# NATIONAL BOARD Task GROUP LOCOMOTIVE BOILERS

## Minutes

Meeting of July 15<sup>th</sup>, 2019  
Kansas City, MO

Item 19-17: Interpretation of Part 3, S1.2.11.3  
Submitted by: Brendon Hilton [bwhilton80@msn.com](mailto:bwhilton80@msn.com)

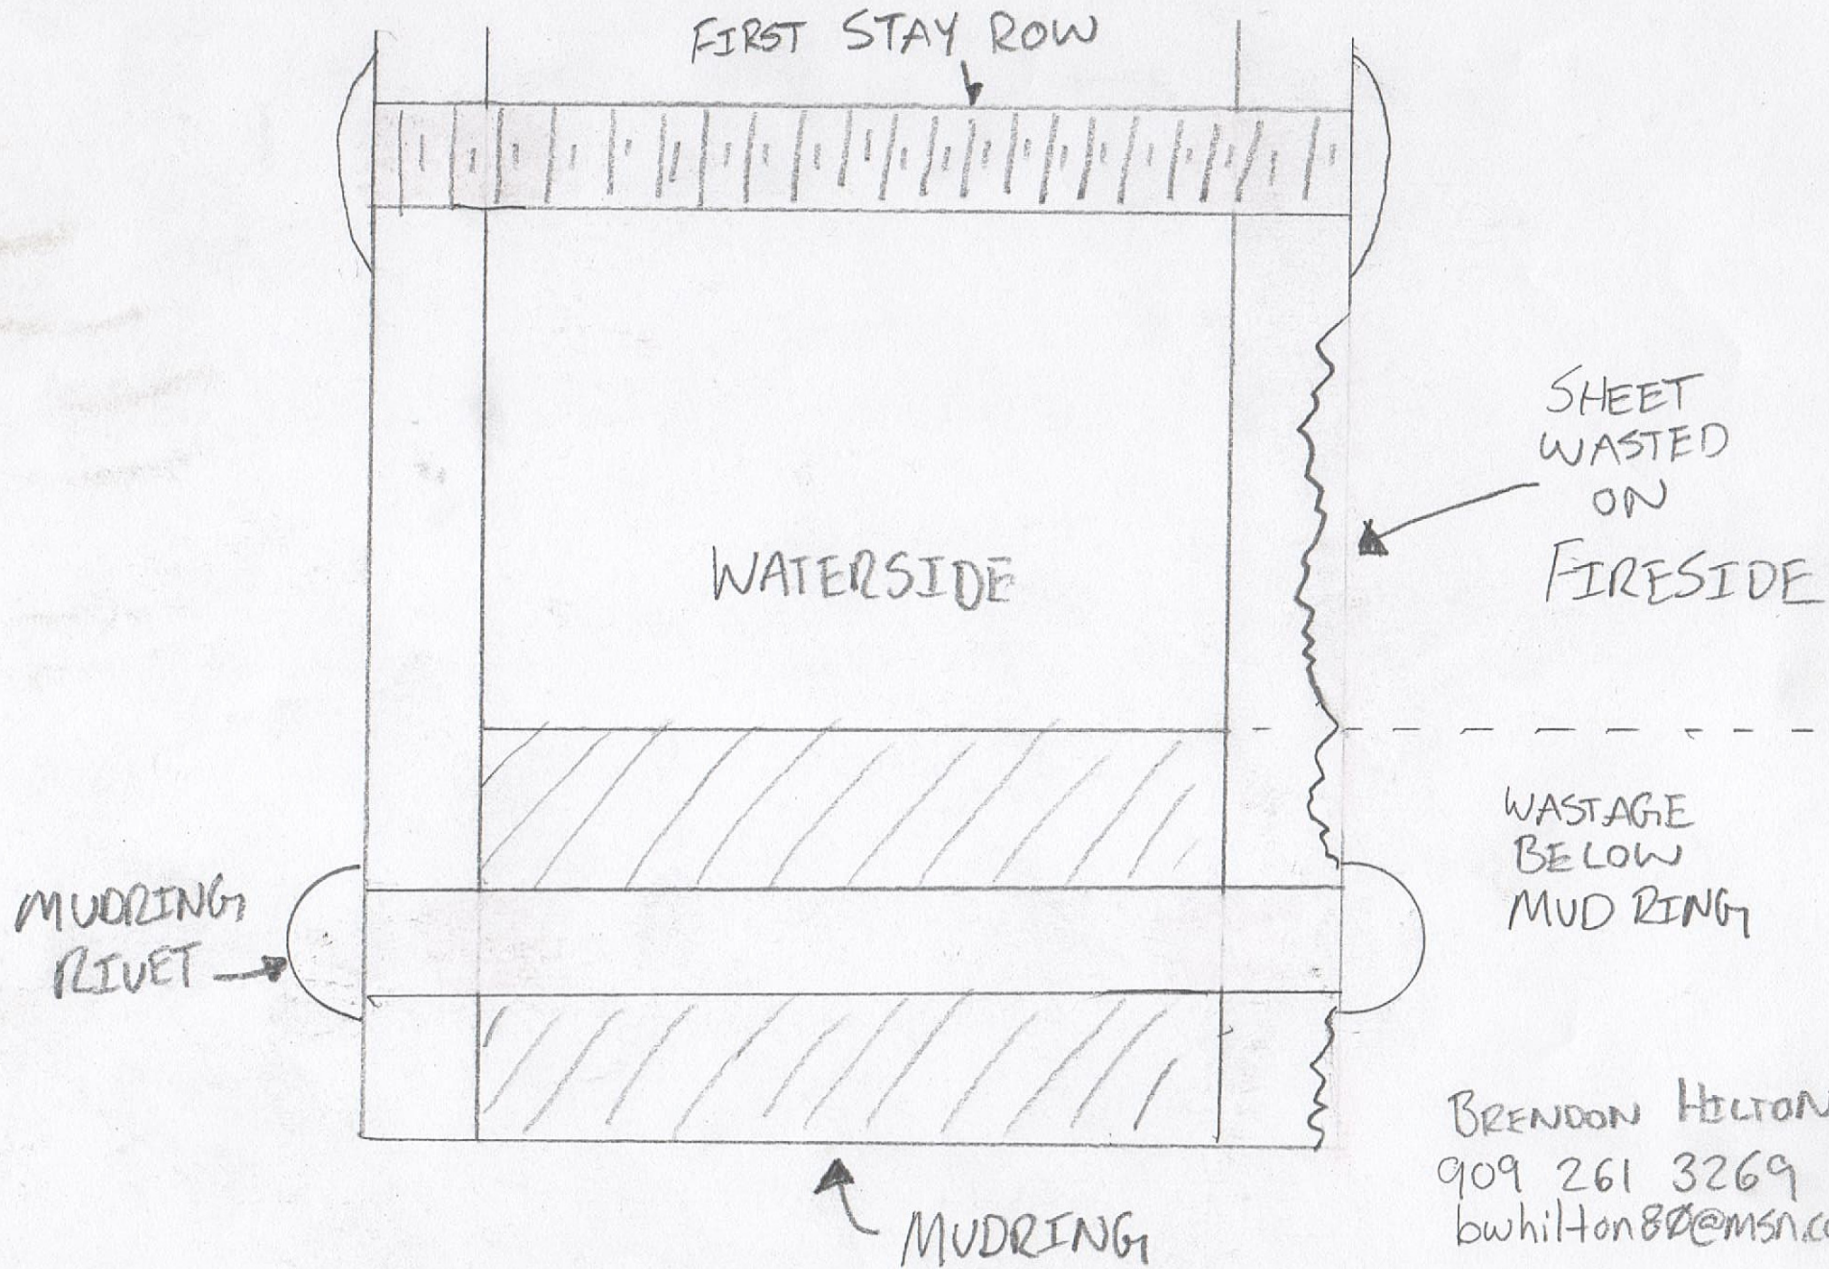
Background - This question is in regards to a CFR 230, 1472 day boiler inspection on a 1927 built Baldwin 4-8-4 steam locomotive. The door sheet (aka back sheet) in the firebox has sustained wastage at the mudring on the fireside, caused by the proximity of the firebrick. In the figure S1.2.11.3, the drawing indicates a wastage on the waterside, yet the text of section S1.2.11.3 does not specify if it is referring to the waterside, the fireside, or both. Please see attached diagram of the wastage in question.

Question - If the majority of the wastage is on the fireside, and there is minimal wastage on the waterside, does NBIC Part 3, 3.3.4.3-a govern repairs?

QUESTION: IF THE MAJORITY OF WASTAGE IS ON THE FIRESIDE, DOES  
RULE 5.1.2.11.3 STILL GOVERN REPAIR?

Answer - Yes
